## Staff Report to the Planning Commission

Application Number: **07-0267**

**Project Description:** Proposal to expand an existing agricultural research facility to include construction of 7028 square feet of offices, 9044 square feet of greenhouses, 3370 square feet of laboratories, a 3514 square foot office/conference room; expansion of the parking area; relocation of a 1152 square foot greenhouse; the removal of two temporary trailers; and associated site improvements. Requires an Amendment to Commercial Development Permit 88-1104 and an Agricultural Buffer Determination.

**PRELIMINARY DRAINAGE PLAN**

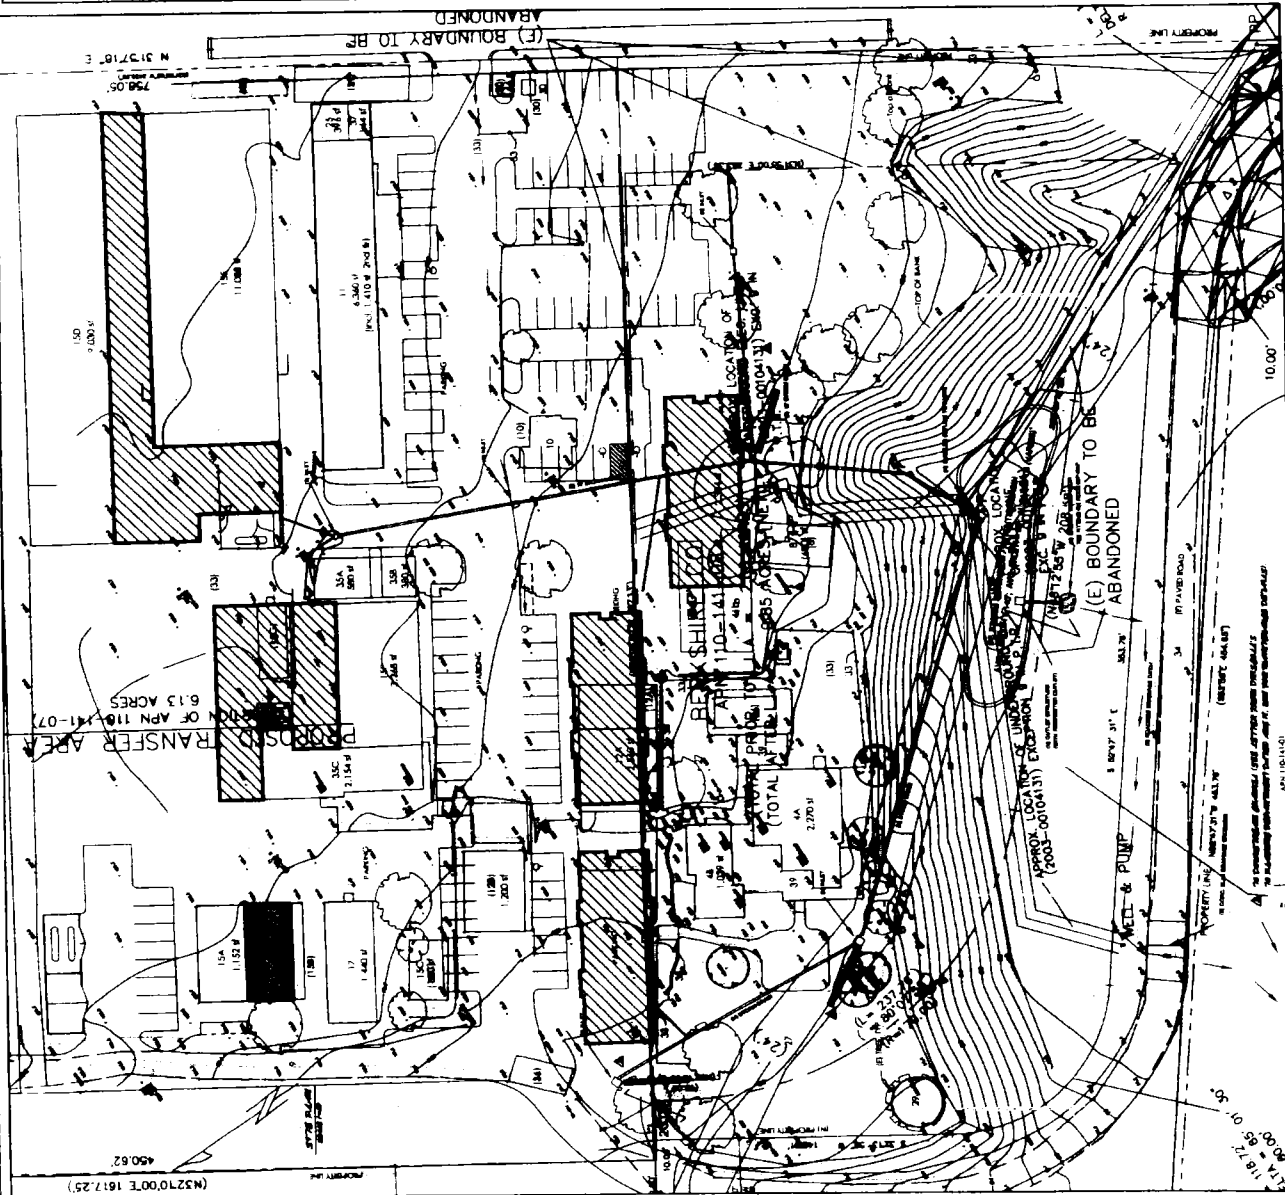
1) Show how site runoff is proposed to be handled until it reaches a safe point of release such as an adequate drainage system or a water course. Sheet P-1 - Preliminary Drainage Plan - 2nd submittal - indicates water will ultimately flow into an existing roadside drainage ditch flowing west - southwest. However County hydrology maps indicate that this ditch dead ends after another +/- 1000 feet. Which leads to the comment#2:

3) Quantify the flow from offsite upstream drainage areas draining toward the site and show how the flow will be handled. Sheet T-1 (topo map) indicates that there is a ridge line potentially dividing the drainage path. The proposed drainage design appears to collect and route runoff to a single dispersion point from a different drainage path. This is considered a diversion of the natural drainage pattern. Information substantiating the diversion must be submitted for review. If the diversion is found to be allowable in this design an assessment of the path to be diverted to must be submitted. Off-site information must be included as requested in comment #2.

ADDITIONAL 2nd REVIEW COMMENTS: 4) Preliminary Drainage Plan Sheet P-1 indicates either detention or retention. Please note, utilizing only detention to meet mitigation requirements for increases in runoff is only allowed if other measures are not feasible. If detention is the only method available to meet pre-development requirements, please submit reasons of infeasibility for review.
